**Date:** 4<sup>th</sup> June 2002  
**Client:** Good Technology  
**Project Number:** GDTB-G100-SAR-3879  
**Contact:** Louie Sanguinetti  
**FCC ID:** PX3G100

Below is the response to the questions from the FCC in respect to the G100 portable device.

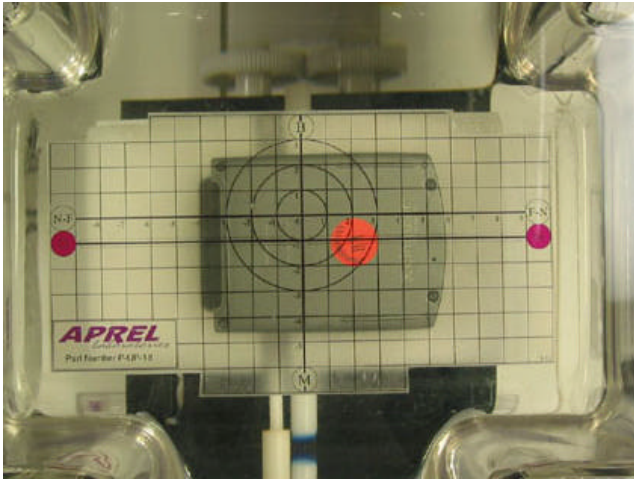
- 1) *Need external photos with side views of device in holster please. Manual does not show holster option?***

Below is a side view of the device located in the holster.

Top View No Holster

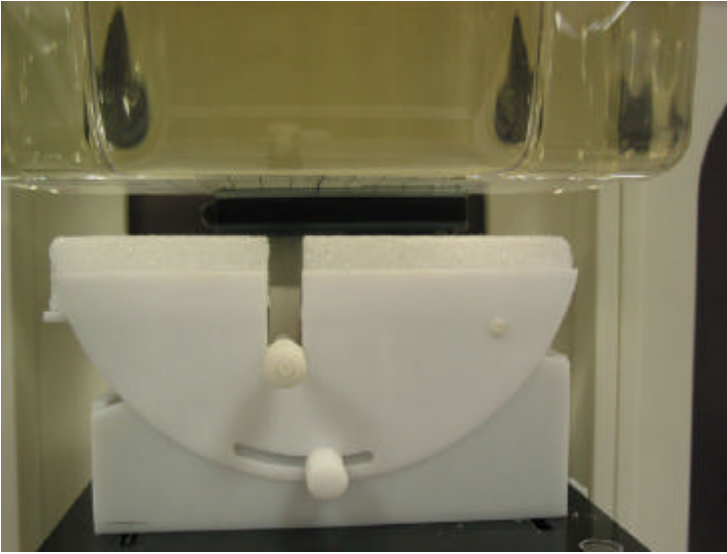
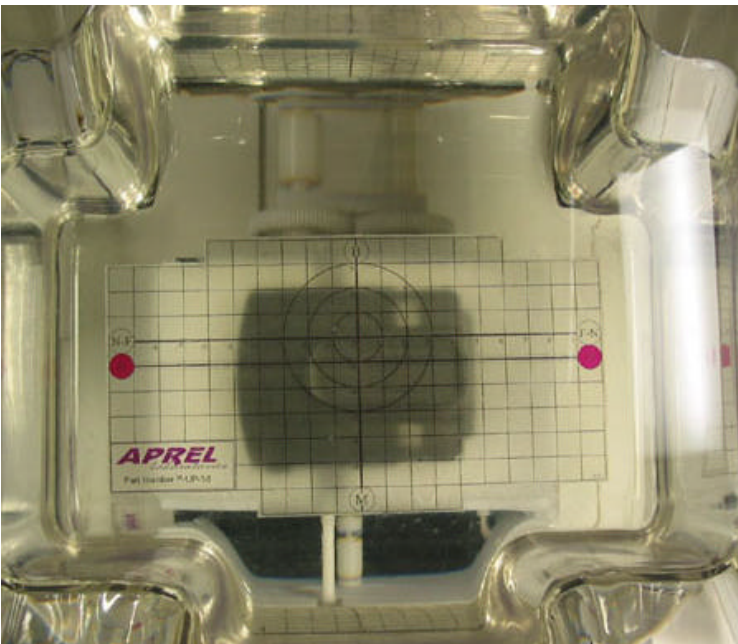
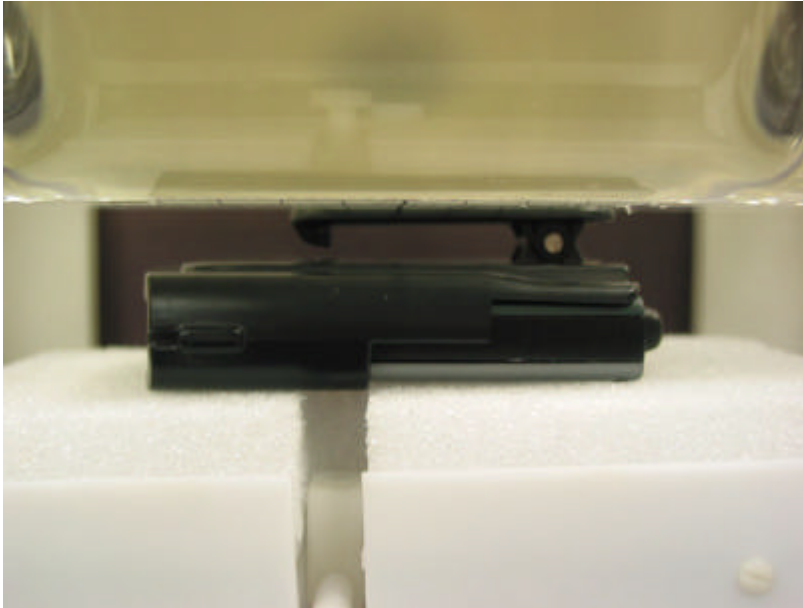
- 2) ***Need photos of EUT holder and setup with device in place as used for SAR test.***

Below are the views of the device while set-up for the SAR tests.
